**MINUTES OF A REGULAR MEETING OF THE DESIGN REVIEW BOARD OF THE TOWN OF CLARKDALE HELD ON WEDNESDAY, APRIL 6, 2016, AT 6:30 P.M. IN THE MEN’S LOUNGE OF THE CLARK MEMORIAL CLUBHOUSE, 19 N. NINTH STREET, CLARKDALE, AZ.**

- a. **CONSIDERTION AND POSSIBLE ACTION DRB #091228:** Discussion/possible action regarding a monument sign application for Sedona Wellness, a new business location at 414 Peace Garden Path, parcel # 400-07-026F.

- b. **CONSIDERATION AND POSSIBLE ACTION DRB #091231:** Discussion/possible action regarding an application for design review of a proposed RV resort and associated site improvements on the 9.52 acre parcel, located at 551 S. Broadway , Parcel # 400-07-005.

Figure 1- Proposed Monument signs

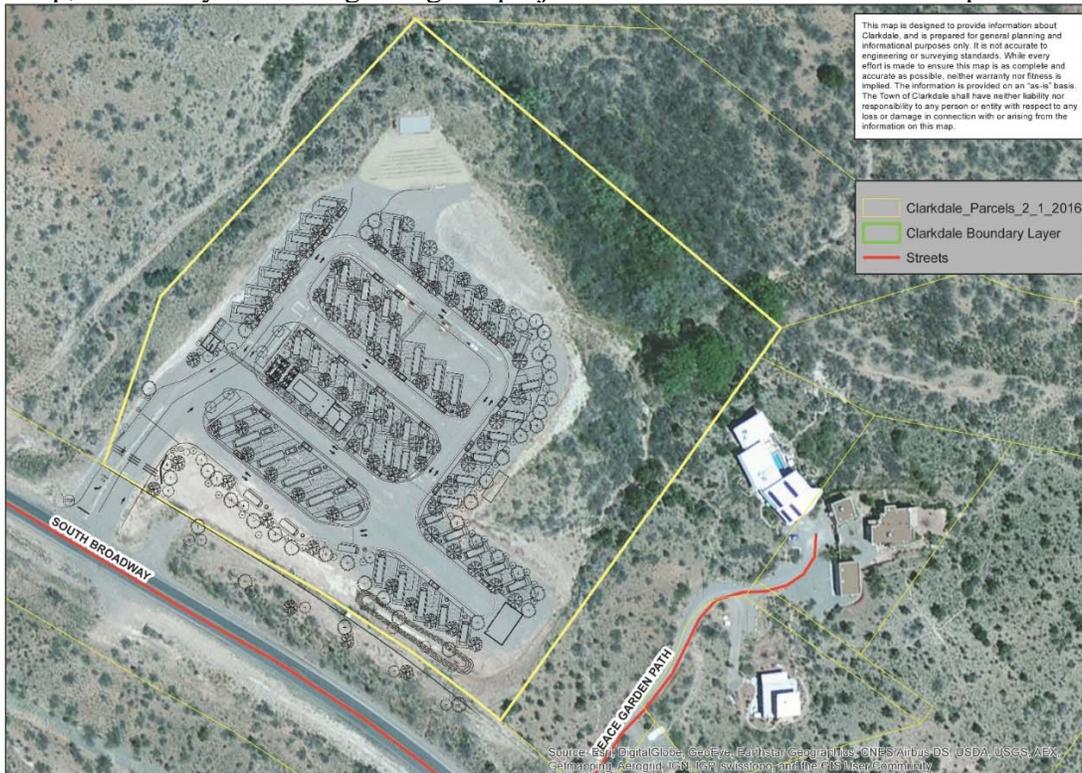
The proposed walls onto which letters will be mounted will be smooth sand stucco texture painted Elastomeric Moraco tan. Sign walls will not exceed 8' tall, one on each side of the entrance. The signs will be made of weathered steel; letters will be 22" tall, and each sign will be 4 ½' tall x 14' wide and ¼" thick. The sign letters will be mounted off the monument face 1". Wall sign will be illuminated by 3 120V / 1,710 lumens aluminum RLM classic emblem Bronze Platina angle shade downward facing lighting on each monument. The lighting will be on a timer to turn off at 10:00 P.M. The address will be displayed on the lower part of the monument walls.

- 1. Maximum number equals one per approved wall area. An approved wall area, per Definitions, Chapter Two of the Town of Clarkdale Zoning Code is a wall facing a public street or containing the primary public access.** The proposed wall sign will be visible from S. Broadway and complies with the sign count.
- 2. Maximum height equals top of wall to which affixed.** Application complies.
- 3. Maximum projection from wall surface equals 18 inches, with a minimum clearance of 9 vertical feet if located over a public right-of-way.** The sign letters will be mounted off the wall face 1". Application complies.

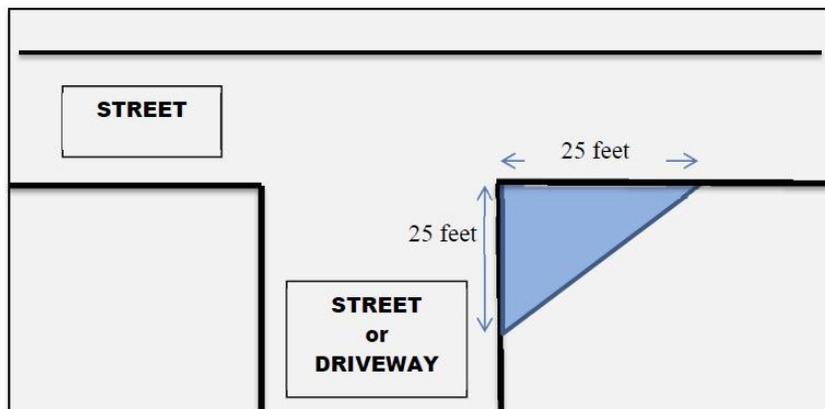
**Zoning Code Chapter 7, Section 7-9 Maximum Sign Square Footage for Commercial Uses:** The property's linear street frontage is 573'. The size of the proposed signs = 252 square feet.

573 total considered linear feet x 1.5 square feet allowed per linear foot = 859.5 total square feet of signage permitted

859.5 permitted signage in square feet – 252 square feet of requested signage per this application = 607.5 square feet remaining for additional signage

Application complies.
